FIELD STONE @ CHESTER SPRINGS
 ASSISTED LIVING FACILITY
 1458 YERS RD
 CHESTER SPRINGS, PA 19375

Sheet Name:	TYPICAL UNITS
Progress Prints:	05/06/2022 PERMIT/BID SET
Revisions:	ADD: 1 CONSTRUCTION SET: 07.1.22
	REVISED: 08.2.22
	BULLETIN: 8.2.23

REVISED

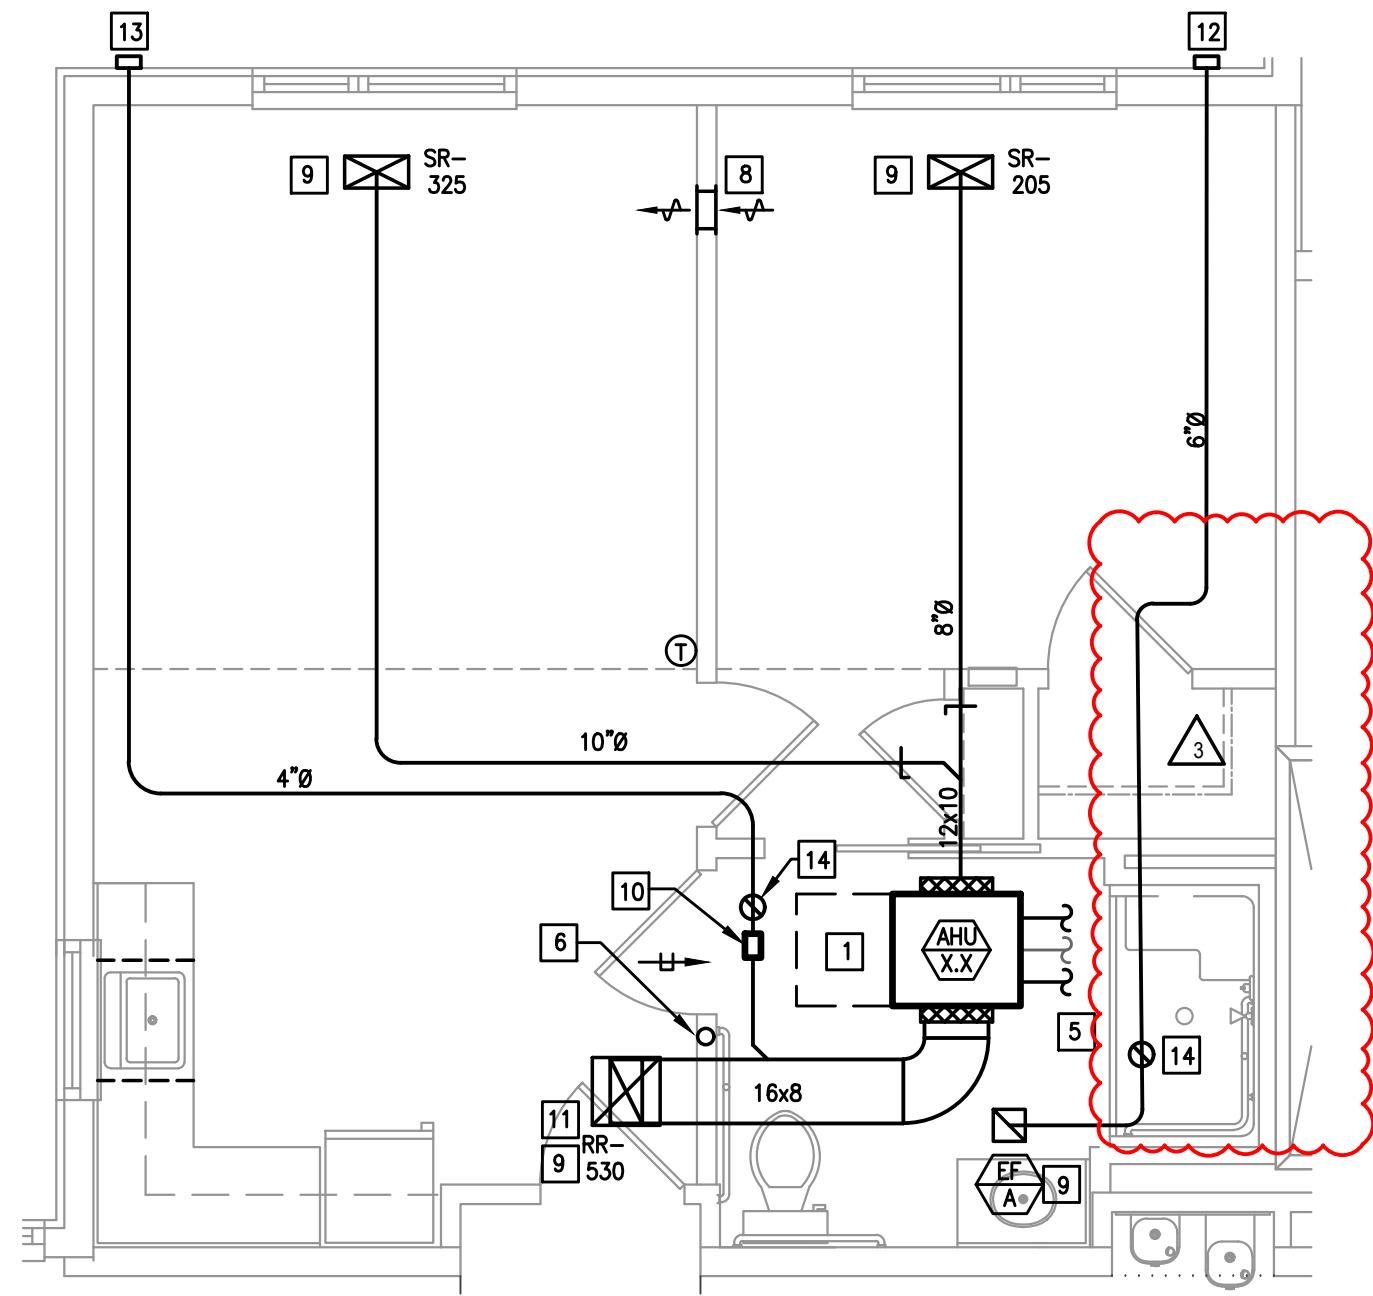
For the third floor units, ductwork is to be removed when shown where a drop ceiling is not located. Air devices are to be located sidewall where the ceilings transition from drop ceilings to the higher ceilings below structure. Refer to markups for routing, sizes, and CFMs.
